**Temporary Private Vehicle Park (Private Cars and Light Goods Vehicles Only)
for a Period of 3 Years and Associated Filling of Land in “Green Belt”, “Village
Type Development” and area shown as “Road”
Various Lots in D.D. 26, Shuen Wan Chim Uk, Ting Kok, Tai Po, New Territories
(Application No. A/NE-TK/800)
Submission of Revised Stormwater Drainage Proposal**

Further to your email with comments from Drainage Services Department (DSD), we are pleased to tabulate the following responses to your comments for your easy reference:

DRAWING TITLE:
DRAINAGE PROPOSAL PLAN AND TYPICAL DETAILS

SECTION D – D WITH DESILTED TRAP
COMPLY WITH CEDD'S DRAWING NO. DS C2405 AND C2406I

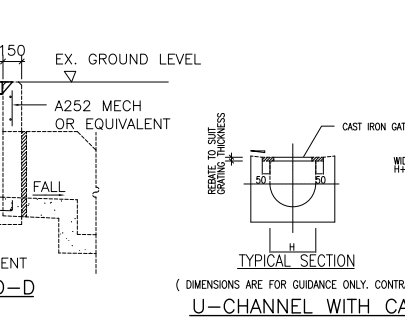
Item	DSD comments	Our Responses
(a)	R to C Item H refers. Please indicate on the drainage proposal that catchpit with trap (CP19) will be provided. Details of the catchpit with trap should also be provided.	The "existing catchpit CP19 to be modified to desilted catchpit" is already marked on drainage plan and the details of desilted catchpit is provided in this resubmission.

TYPICAL SECTION CAST IRON GRATING
(DIMENSIONS ARE FOR GUIDANCE ONLY. CONTRACTOR MAY SUBMIT EQUIVALENT TYPE)
U-CHANNEL WITH CAST IRON GRATING

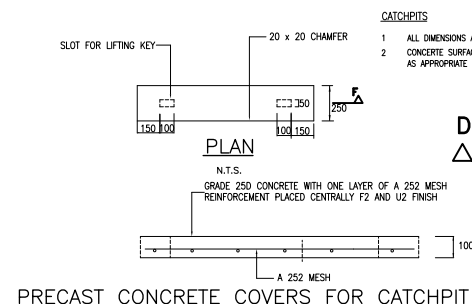
(b)	It is noted that the existing 375 U-channels between catchpits CP15 and CP20 will be upgraded to 450 U-channels. Please advise if the invert levels of the proposed 450 U-channels will be same as the invert levels of the existing 375 U-channels. Details of the proposed u-channel and its grating cover should also be provided.	The invert level of the catchpit CP15 to CP20 and proposed 450UC is already revised in this resubmission. Besides, the details of u-channel and its grating cover are provided in this resubmission.

SECTION A-A
(NO FILLING AND EXCAVATION WORKS IS PROPOSED)

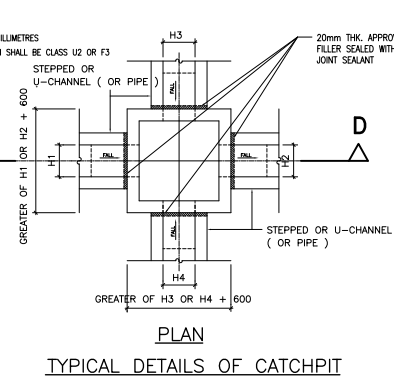
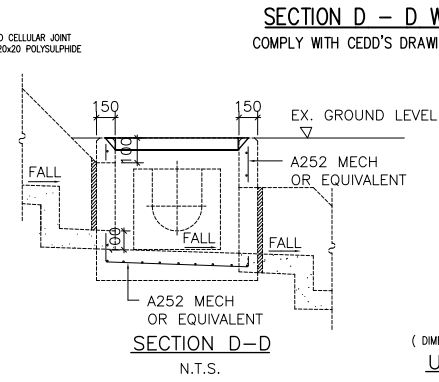
(c)	Sections A-A, B-B and C-C do not match with the existing site condition. Please review.	The section A-A, B-B and C-C is revised to match with the existing condition in this resubmission.
